Subject ▶ Change on base, strain relief, etc.

For Models ▶ 2708 (Table Saw)

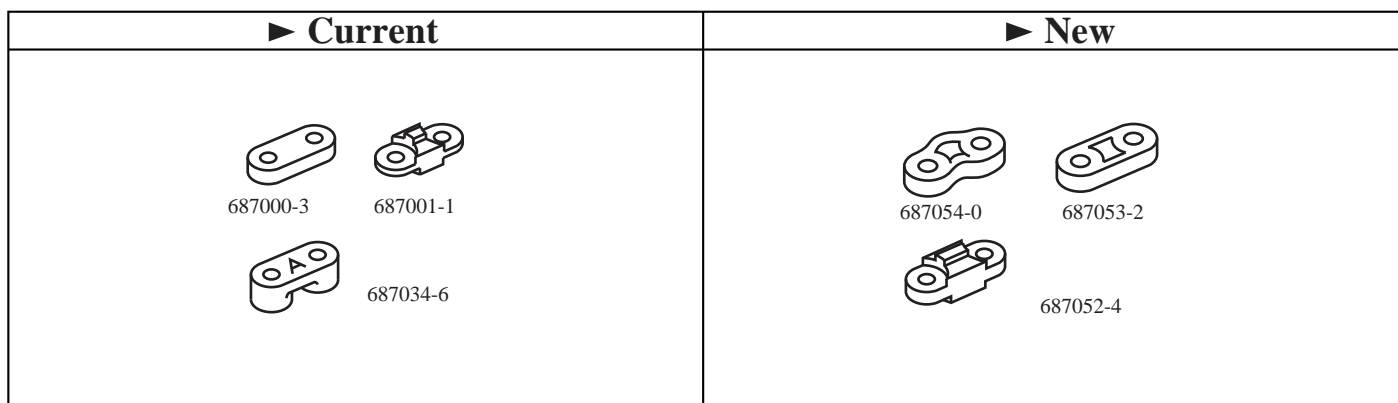
1. Base

*The pitch between the screw holes for securing the strain relief will be changed from 15 mm (19/32") to 20 mm (25/32").

*The screw holes will be changed from tapped holes 4 mm (5/32") in dia. to non-tapped holes 3.25 mm (1/8") in dia.

2. Screw for securing the strain relief

The pan head screws M4x25 will be changed to tapping screws PT4x18.

3. Strain relief

The pitch between the screw holes will be changed from 15 mm (19/32") to 20 mm (25/32").
